DOCUMENT TITLE: ENTERGY VERMONT YANKEE IMPLEMENTING PROCEDURE CHANGE
COPY NUMBER: 54
CHANGE NUMBER: 219
ISSUE DATE: AUGUST 20, 2003

Subject: Vermont Yankee Nuclear Power Station
License No. DPR-28 (Docket No. 50-271)
Vermont Yankee Emergency Plan Implementing Procedure Changes

OP 3504, Rev. 36, LPC #2

A. Procedure No.: OP 3504	Current Revision #: 36	Title: Emergency Communications
B. Description of Change: <ul style="list-style-type: none"> • Added description of new PARD circuit. • Fig 5 - updated phone arrangement in RP offices • Added description of telephone headsets. • Added 2 fax machines and moved VT State Liaison on Figure 6 • Removed the NAS phone numbers in App A and Figure 9 • Updated phone numbers in App B

Figure 9
OP 3504 Rev. 36
Page 1 of 1
LPC #2

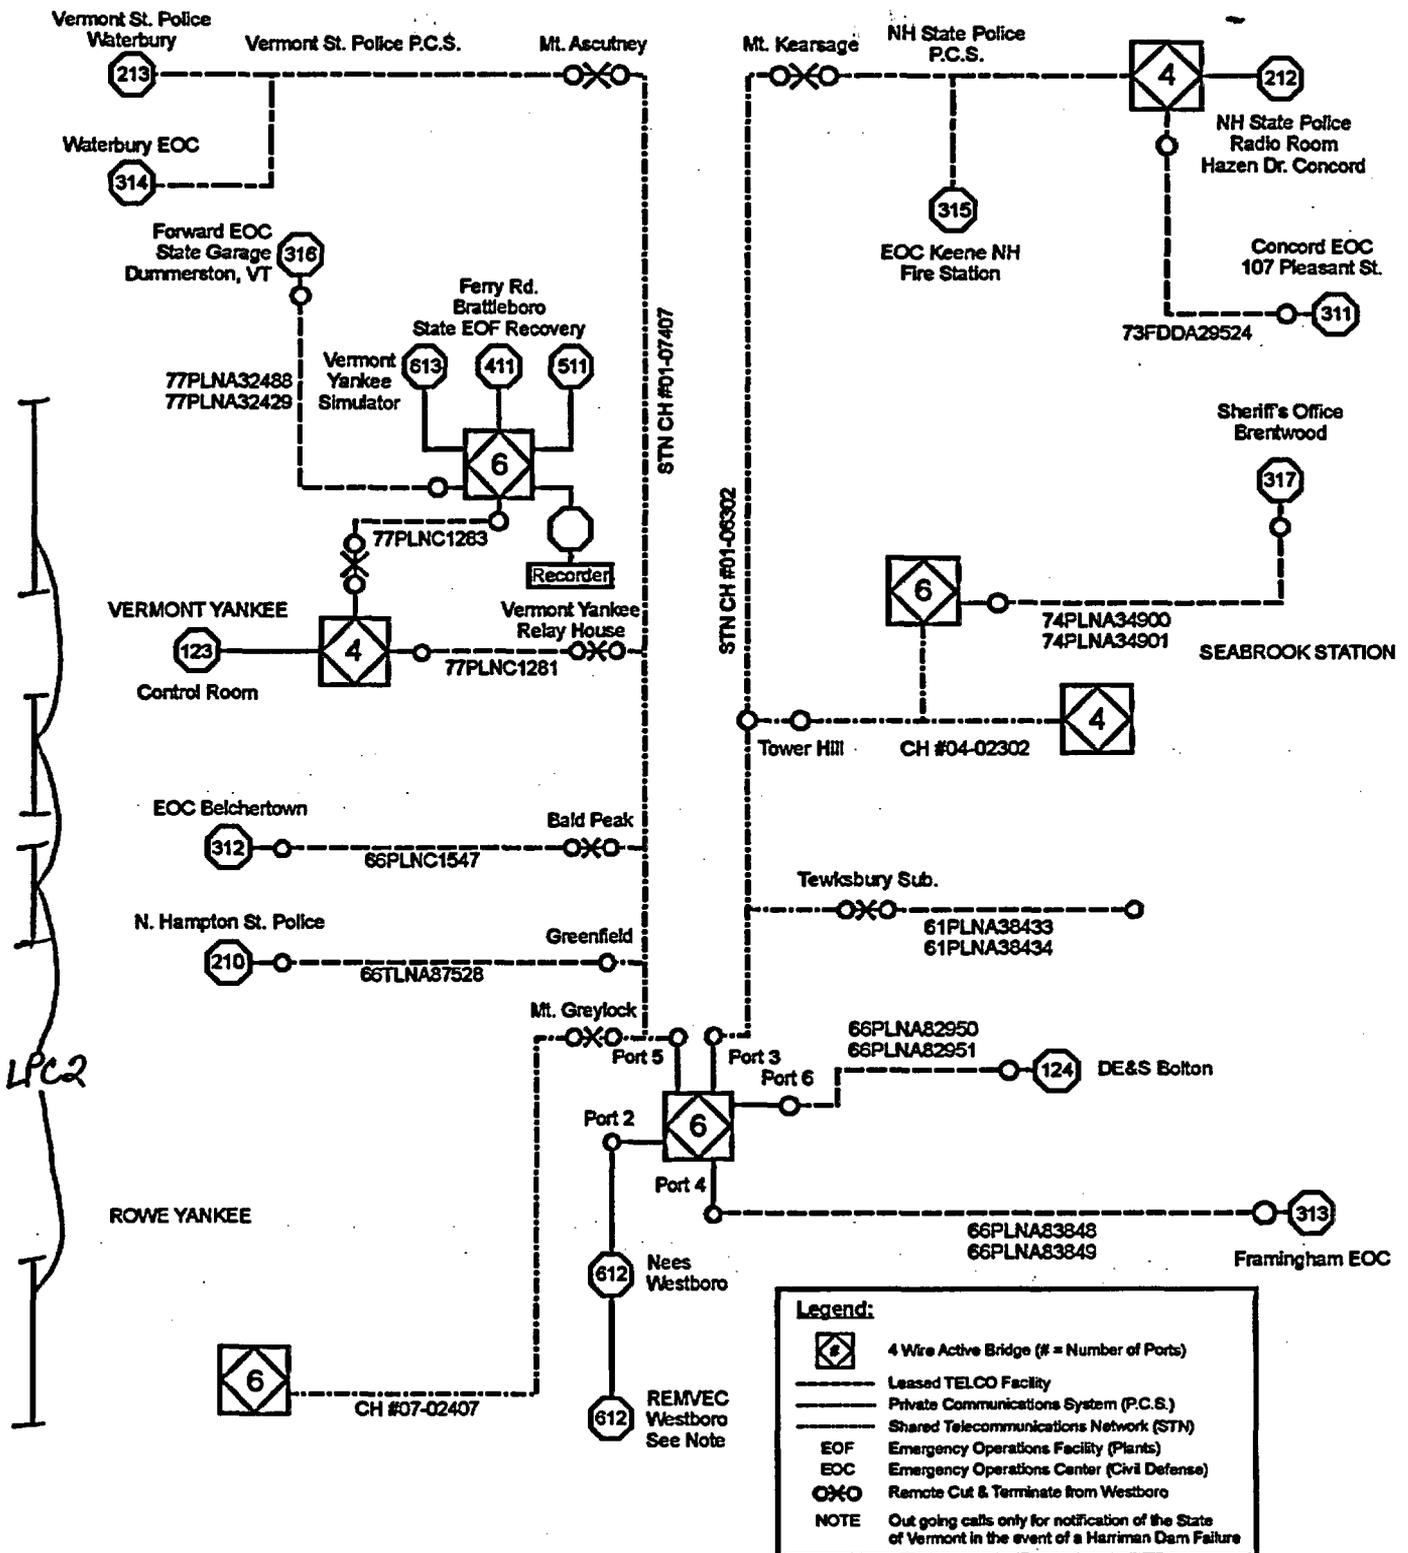
NAS stations removed from service by Yankee Rowe and Seabrook. None of the stations used by Vermont Yankee were removed.
